\_\_\_\_\_  
In the Matter of )  
 )  
Application of Motorola Global Communications, )  
Inc. For Authority to Launch and Operate the )  
Celestri Multimedia LEO System, a Global )  
Non-Geostationary Orbit Satellite System in the )  
Fixed-Satellite Service )  
\_\_\_\_\_ )

File No. 79-SAT-P/LA-97

REPLY COMMENTS OF  
LOCKHEED MARTIN CORPORATION

**Figure 1 - Comparison of Antenna Off-Axis Gain Patterns (ITU-R S.672-3 vs ITU-R Appendix S8)**

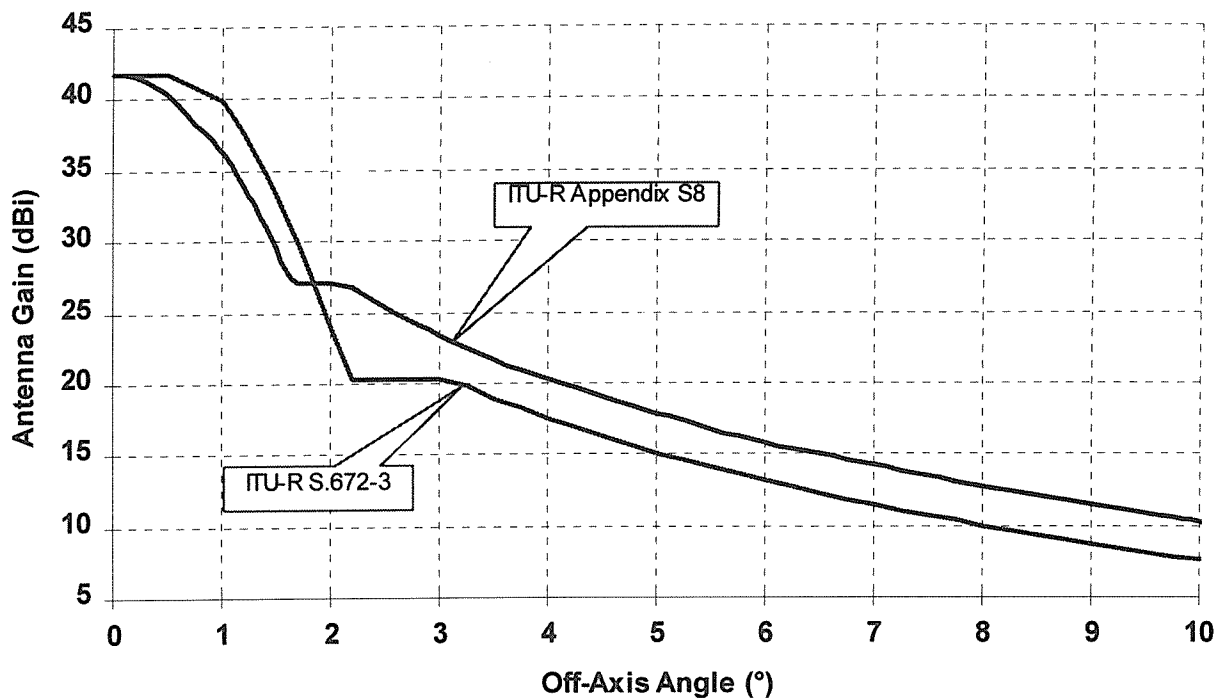
Motorola also mistakenly assumes that the GSO FSS receive earth station characteristics meet the off-axis gain envelope contained in ITU-R S.672-3.<sup>28</sup> This ITU Recommendation is

entitled "Satellite Antenna Radiation Pattern for Use as A Design Objective in the Fixed-Satellite Service Employing Geostationary Satellites," and clearly relates to *satellite* antennas, not *earth station* antennas.<sup>29</sup> A more appropriate off-axis gain envelope for this interference analysis would be the one that Motorola assumes for its own earth stations, which is given in Annex III of ITU Appendix S8 (entitled "Radiation Patterns For Earth Station Antennae To Be Used When They Are Not Published").

Figure 1, below, plots both of these off-axis gain envelopes for a 70 cm receive earth station antenna and shows that there is a considerable variation between them.

In the important off-axis angle range of 2° to 10°, the mask used in the Motorola analysis is between 3 and 6 dB more stringent than that given in Appendix S8. This results in a correspondingly more optimistic assessment of interference by Motorola's Celestri LEO System.

Figure 2 - Comparison of CPM-95 Interference Criteria and New Proposal by Motorola (Celestri into GSO)

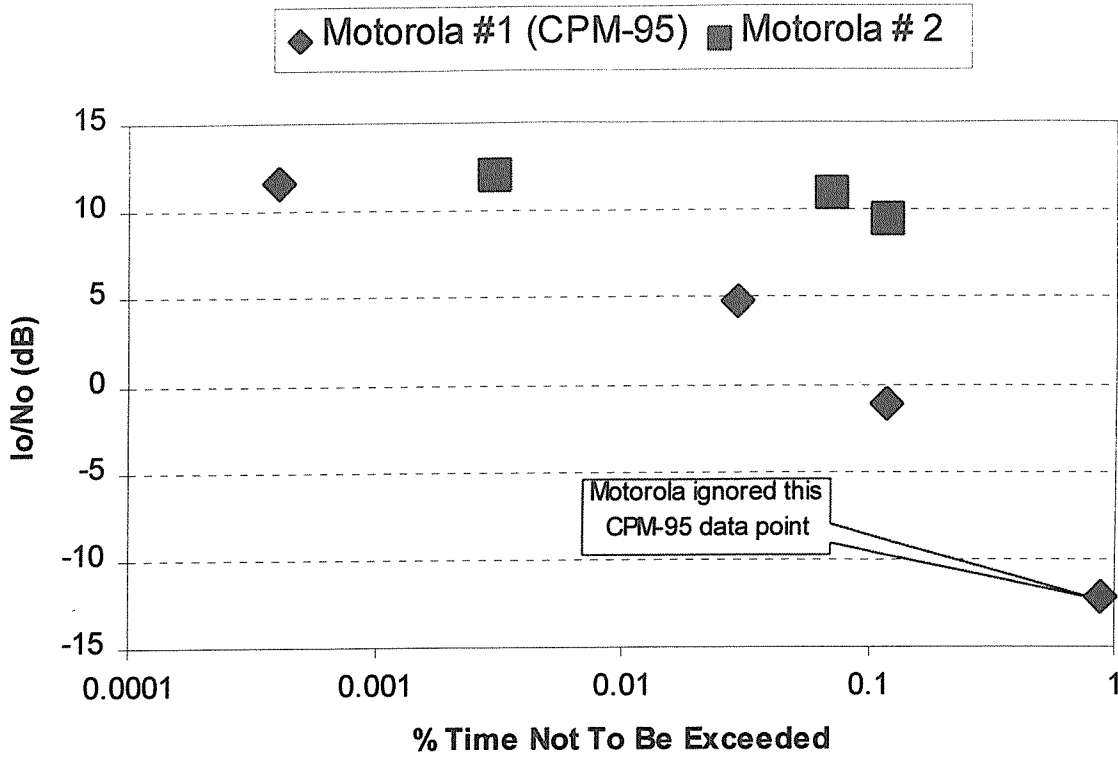
Motorola's proposed interference criteria for Celestri LEO interference into GSO FSS systems also contain significant technical inconsistencies or omissions.<sup>30</sup> In the Celestri LEO application, for example, Motorola proposes to use the interference criteria developed at CPM-95.<sup>31</sup> Although the CPM-95 interference criteria contain four data points, Motorola does not include one of these critical data points ( $I_o/N_o = -12.2$  dB for not greater than 0.87% of the time) because, even under its optimistic analysis, the Celestri LEO System cannot meet this criterion.<sup>32</sup>

Rather, in the *Celestri Sharing Study*, Motorola proposes to alter significantly the accepted CPM-95 interference criteria in a manner which is highly prejudicial to GSO FSS systems. Figure 2, below, demonstrates the substantial differences between the interference criteria.

At the 0.1% level, for example, Motorola has proposed an interference criterion more than 10 dB worse than the CPM-95 criteria. It is procedurally inappropriate, and Motorola should not be permitted, to redefine established interference criteria through an ad hoc approach to match the characteristics of its system. Instead, in view of the secondary status of NGSO FSS operations in the primary GSO FSS bands, the Celestri LEO System must be redefined, at a minimum, to satisfy interference criteria that will ensure that no interference will be caused to GSO FSS systems.

Figure 3 - Celestri Constellation Performance

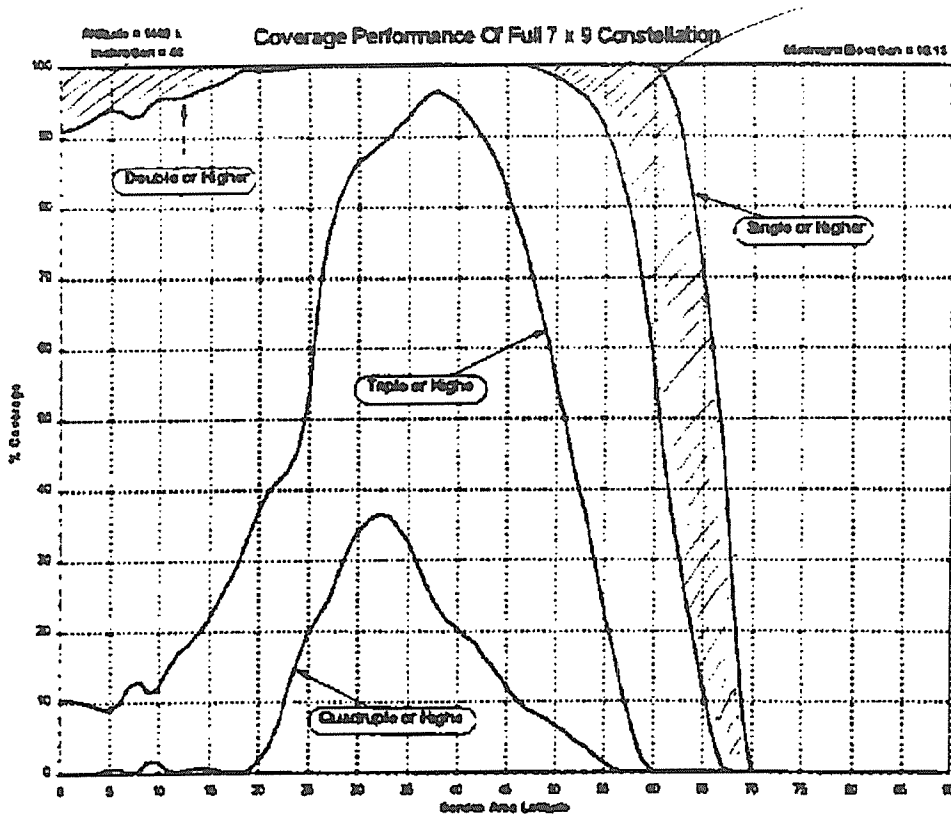
Figure 3, a reproduction of Figure IV-5 of the Celestri LEO application (with shading added), shows the number of satellites in view from various latitudes on the Earth's surface. The hatched area indicates situations in which it is not possible to implement satellite diversity because only one satellite will be visible.

Motorola proposes to offer Celestri LEO services at latitudes of  $\pm 60^\circ$  (with a  $16^\circ$  minimum elevation angle), and up to  $\pm 70^\circ$  if lower elevation angles are used. At latitudes above  $\pm 67^\circ$ , satellite diversity cannot be utilized because there is never more than one satellite visible. At latitudes of  $\pm 60^\circ$ , there is only a 55 percent chance that more than one Celestri LEO satellite will be visible. Even at latitudes of  $\pm 50^\circ$ , which include high-population areas of Europe such as London, Frankfurt, Brussels, etc., the Celestri LEO System is unable to provide dual-satellite coverage at all times. A similar problem exists for latitudes below  $\pm 20^\circ$ .

During periods of single-satellite coverage, it is simply not possible to implement the satellite diversity technique for the purpose of preventing interference to GSO FSS systems. In the event of an interference alignment situation, the Celestri LEO System would either cause

unacceptable interference into GSO FSS systems or would have to cease transmissions. Given this situation, the Commission should require Motorola to demonstrate that the Celestri LEO System can and will implement an effective satellite diversity scheme in all situations where such interference might be caused to primary GSO FSS systems.
